**DECISION No 03/2023
OF THE EUROPEAN UNION AGENCY
FOR THE COOPERATION OF ENERGY REGULATORS**

**on the long-term capacity calculation methodology
of the Core capacity calculation region**

Figure 1: ACER’s experimentation: comparison of Core NTC-based yearly auctions from 2020 with simulated flow-based yearly auctions with the same network security level

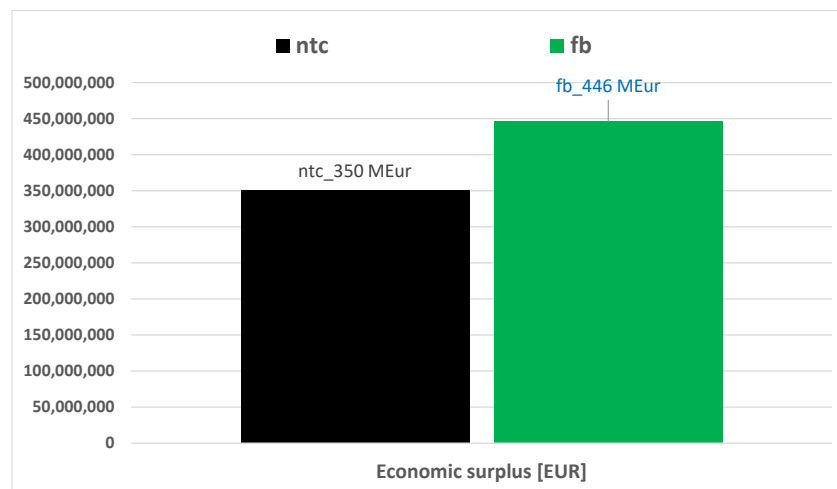
- (iii) The outcomes of yearly NTC-based auctions from 2020 (data marked with 'ntc' in Figure 1) were compared with the simulated flow-based yearly auctions (data marked with 'fb' in Figure 1) with the same bids from the realised yearly auctions. At the 'fb' auctions, the calculated flow-based parameters were adjusted with the minimum RAM which reflects the NTC values applied at the yearly auctions, thus providing the same level of system security for both the currently applied NTC approach and the proposed flow-based approach;

- (iv) The simulations have shown that the application of the flow-based approach increases economic efficiency in the Core CCR (characterised by highly meshed network and physically interdependent bidding zone borders) while maintaining the same level of system security. In such circumstances, the flow-based auctions ('fb') provide a 27% higher economic surplus (increase from 350 million EUR to 446 million EUR).

Figure 2: ACER's experimentation: comparison of Core NTC-based yearly auctions from 2020 with simulated flow-based yearly auctions with different level of minimum RAM

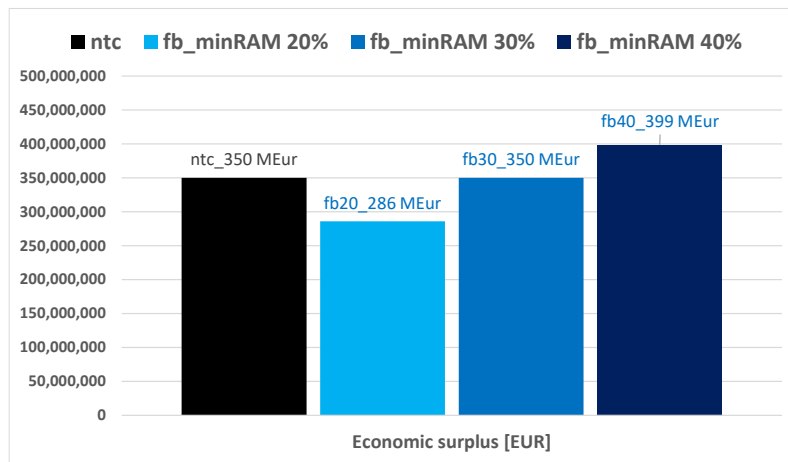
- (a) The results of the experimentation are illustrated in Figure 2, and present the outcomes of flow-based auctions with minimum RAM levels of 20%, 30% and 40% at the yearly flow-based auctions. The auctions with 30% of Fmax provide similar economic surplus as the realised yearly NTC auctions for 2020, along with lower allocated quantities¹⁷;

- (120) On the basis of discussions during the proceedings, applied simulations, and the need to ensure offered capacities at both the yearly and monthly time frame, ACER has amended Article 14 of the Proposal by providing the minimal values of minimum RAM at the level of 20% of Fmax for yearly auctions and 10% of Fmax for monthly auctions.
